## **Change in Packaging Box to Prevent Tampering with MELSEC iQ-R Series Products**

September 2022 (Ver. D: October 2024)

FA-A-0384-D

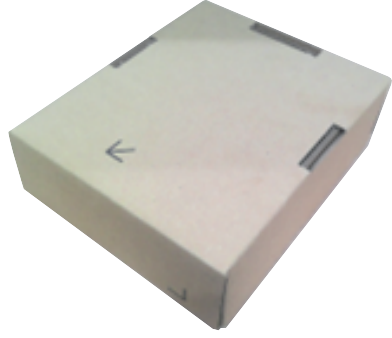
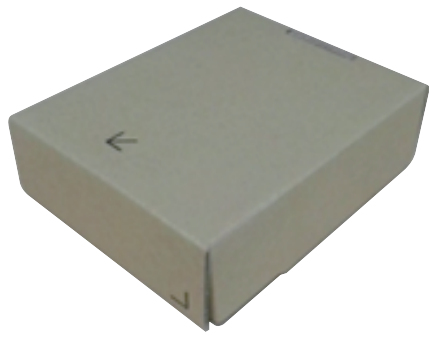
The following table lists the relevant models.
